ISO/IEC JTC1/SC2/WG2 N 5021R
Date: 2019-02-07

Doc. Type: Disposition of comments

Title: Disposition of comments on ISO/IEC CD 10646 5th edition

Source: Michel Suignard (project editor)

TE.6. Page 2768, A.5.10 390 MOJI-JOHO-KIBAN IDEOGRAPHS-2016 and A.5.11 391 MOJI-JOHO-KIBAN IDEOGRAPHS-2018

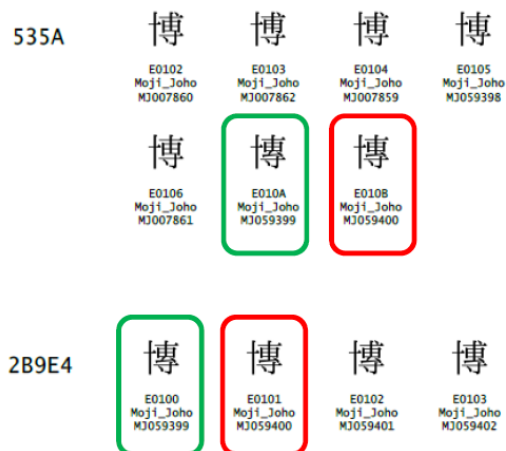
In IVD registration of Moji_Joho collection ([Registration of additional sequences in the Moji_Joho collection, dated 2017-12-12](#)), it is found that two different IVSs are registered for one glyph redundantly. As shown in the following figure, [535A E010A] and [2B9E4 E0100] are registered for Moji_Joho MJ059399, also [535A E010B] and [2B9E4 E0101] are registered for Moji_Joho MJ059400.

Proposed change by Japan.

- In JMJKI-2018.txt, delete <535A E010A> and <535A E010B> in the line starting from "535A."
- Associating with this change, add the following statement in Page 2768, Annex A.5.10 390 MOJI-JOHO-KIBAN IDEOGRAPHS-2016 as NOTE, such as "<535A,E010A> and <535A,E010B> have been removed in collection 391."
